Work Order ID 156219

Item Name: Replacement Skidtube (Fits LH or RH)

DRAWING NO. D2650	TITLE 206/407 SKIDTUBE ASSEMBLIES	REV. F	DART AEROSPACE LTD ENGINEERING ORDER		D.E.O. NO. D2650-F-1	SHEET NO. SHEET 1 OF 1	SCALE NTS
DRAWN <i>AP</i>	CHECKED <i>A.P.</i>	MFG. APPR. <i>AA</i>	APPROVED <i>TH</i>		DE APPR. <i>TH</i>		
DATE 12.10.12	DATE 12.10.22	DATE 12.10.22	DATE 12.10.22		DATE 12.10.22

CHANGE C'BORED WELDED CROSSBOLT SPACERS TO SWAGED SPACERS

WAS:

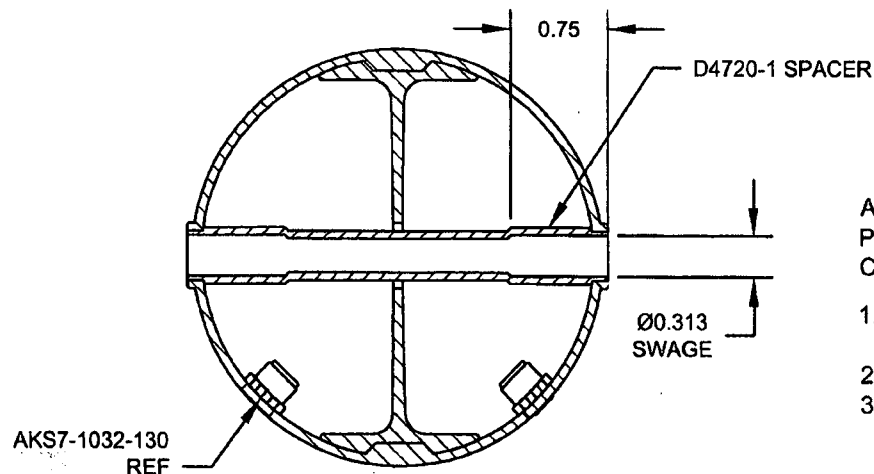
17	18	19	23	D2649	CROSS BOLT SPACER
----	----	----	----	-------	-------------------

ADD DETAIL G BELOW, WHICH IS THE SAME SECTION VIEW AS DETAIL D OF DWG.
C'BORED HOLES ARE NOW SWAGED PER DETAIL G BELOW. FOR THE Ø0.375 HOLE THAT IS NOT C'BORED, WELD PER DETAIL D OF DWG (SEE AMENDED DETAIL B FOR REFERENCE).
